# T ECHNICAL INFORMATION

62824

- Subject** ▶ Change of D-Shaped Side Handle Assembly
- For Models** ▶ HM1100C, HM1140C
- Country** ▶ European countries, Algeria, Reunion
- Description** ▶ D-shaped side handle has been modified as illustrated below.

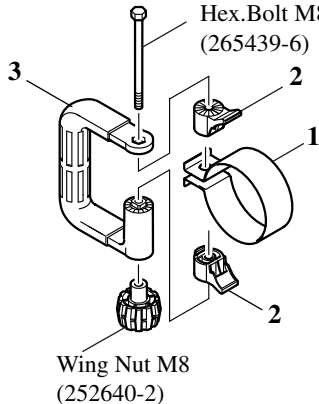
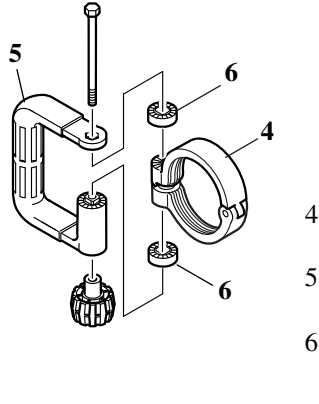
▶ Current	▶ New
<b>Side Handle Assembly (134793-8)</b> (includes 6 components illustrated below.)  <p>Hex.Bolt M8x150 (265439-6)</p> <p>1. Handle Spring 60 (344559-0)</p> <p>2. Handle Base 60 (416396-3) [2 pcs.]</p> <p>3. Side Handle (416009-6)</p> <p>Wing Nut M8 (252640-2)</p>	<b>Side Handle Assembly (134909-5)</b> (includes 6 components illustrated below.)  <p>4. Side Handle Base 60 Complete (152620-7)</p> <p>5. Side Handle (417003-1)</p> <p>6. Side Handle Cam (417002-3) [2 pcs.]</p>
<p>1. Handle Spring 60 (344559-0)</p> <p>2. Handle Base 60 (416396-3) [2 pcs.]</p> 	<p>4. Side Handle Base 60 Complete (152620-7)</p> 
<p>3. Side Handle (416009-6)</p> 	<p>5. Side Handle (417003-1)</p> <p>6. Side Handle Cam (417002-3) [2 pcs.]</p>  <p>The new Side Handle and Side Handle Cam have already been used for HM1202 and HM1202C.</p>

Item No.	Current part		Q'ty	I/C	New part		Q'ty	Note
HM1100C: 071 HM1140C: 018	Handle Spring 60 344559-0		1	No	Side Handle Base 60 Complete 152620-7		1	Interchangeable as a set
HM1100C: 070, 072 HM1140C: 017, 019	Handle Base 60 416396-3		2	No				
HM1100C: 074 HM1140C: 015	Side Handle 416009-6		1	No	Side Handle 417003-1		1	Interchangeable as a set
HM1100C: 070, 072 HM1140C: 017, 019					Side Handle Cam 417002-3		2	
HM1100C: B01 HM1140C: B01	Side Handle Assembly 134793-8		1	←	Side Handle Assembly 134909-5		1

HM1100C: From serial No.34510E (Nov., 2000)

HM1140C: From serial No.2768E (The implementation month will be informed later.)
